Subject: Changes to Historic Site

Bottom: Site plan before rehabilitation. The 1900 house (A) stood alone on its lot. On the adjoining property stood another large house (B1) and a dependent cottage (C1)

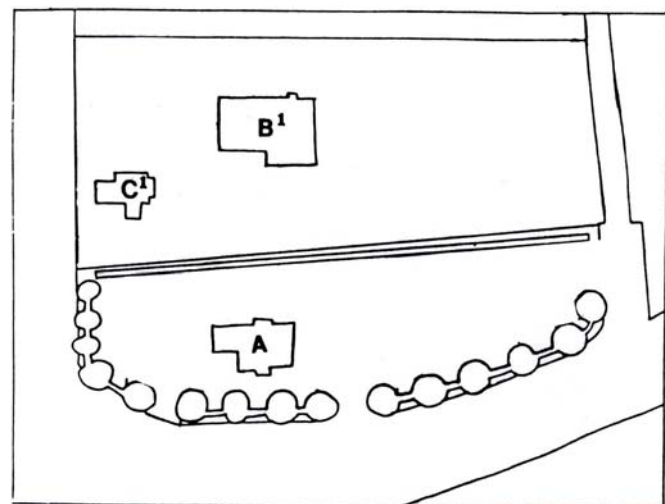
Application (*Incompatible treatment*): A large, finely detailed Neo-Classical mansion, built in 1900 and representing the wealth of prosperous mill owners, was listed individually in the National Register of Historic Places. Although the large lot on which it stood was overgrown prior to the start of the rehabilitation, the character of the house as an imposing suburban residence on a spacious lot had survived.

Top: Although the site was overgrown, the character of this 1900 house as a large suburban residence had survived.

Site plan after rehabilitation of buildings. The neighboring house was moved and turned around (B2) to face the 1900 building (A) across a new paved parking lot. The cottage associated with the moved house was relocated (C2) behind the 1900 building.

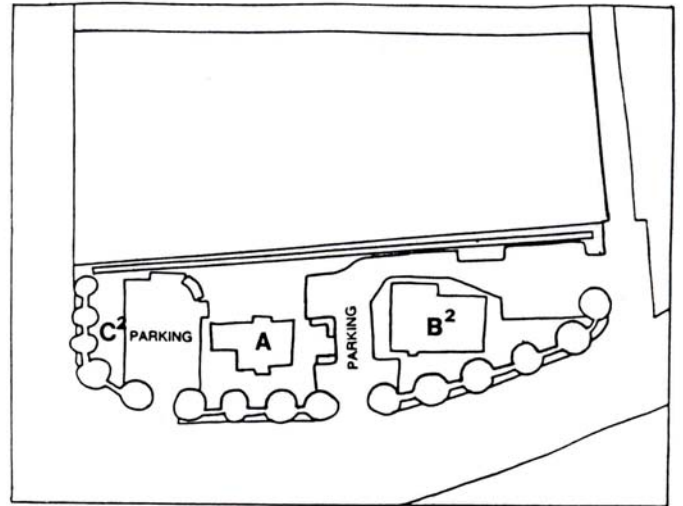
Although both of the moved buildings were saved from demolition, their relocation in the manner shown here has greatly altered the historic setting of the listed build-

ing. The central parking lot, has become a dominant new feature of the site. The historic building now appears as but one element in a new composition bearing little relationship to the historic appearance of the property. As a result, the historic character of the overall property has been greatly diminished, and the project does not meet the Standards.

Turned 180 degrees, the moved building (B2) faces the historic one from a distance of 60 feet.

The new parking lot completes the drastic alteration of the setting. The second relocated structure (C2) can be seen through the porte-cochere at left.
